Rezoning Transportation Analysis

Petition Number: 2022-210

Revision Log:

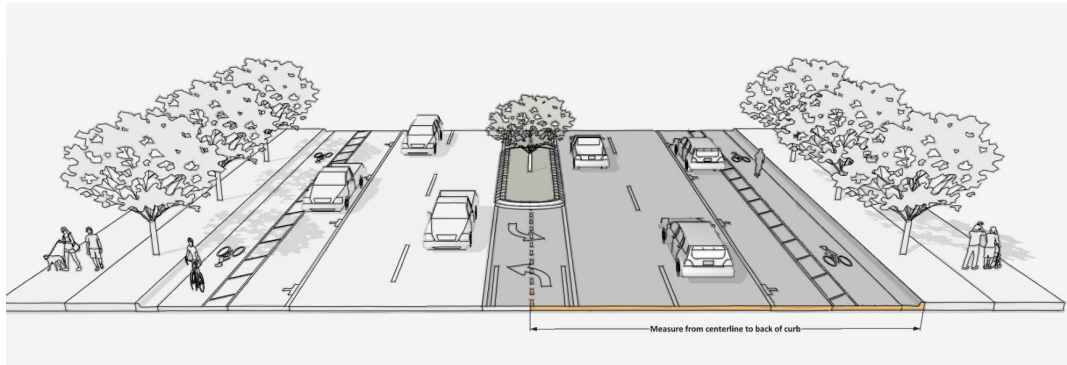
- a. **South Tryon Street:** Location of curb and gutter to be moved a minimum of 42.5 feet from roadway centerline to accommodate the Charlotte Streets Map with a roadway typical section of a 4+ Avenue with Buffered/Separated Bike Lanes and On-Street-Parking.

Outstanding Comment 9.20.23: Label and dimension the curb and gutter from the centerline for each road on the site plan.

Clarifying comment 6.21.23: Label and dimension the curb and gutter from the centerline for Clanton Road and South Tryon Street.

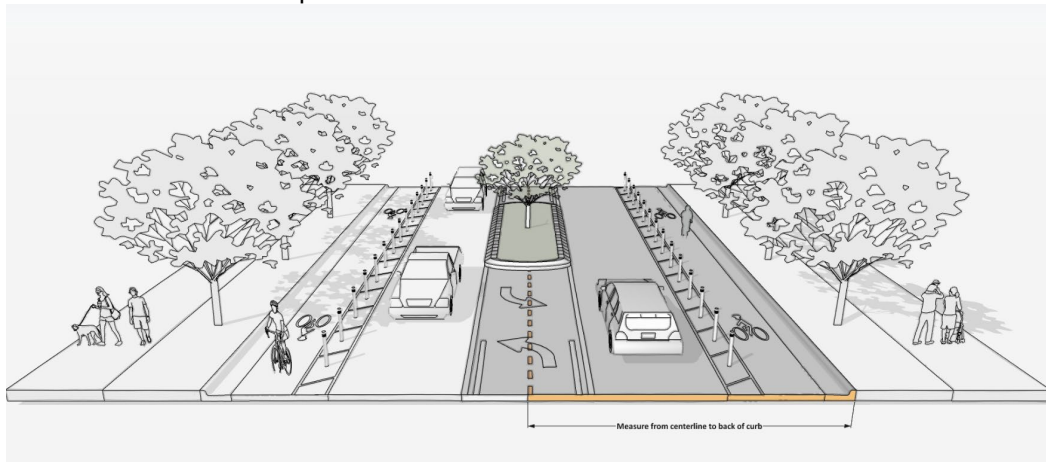
- b. **Clanton Road:** Location of curb and gutter to be moved a minimum of 27 feet from roadway centerline to accommodate the Charlotte Streets Map with a roadway typical section of a 2+ Avenue with Buffered/Separated Bike Lanes.

NOTE: Additional distance from center line to back of curb may be required in locations where a median and turn lanes are required. Final curbline locations to be reviewed by CDOT once TIS is approved.
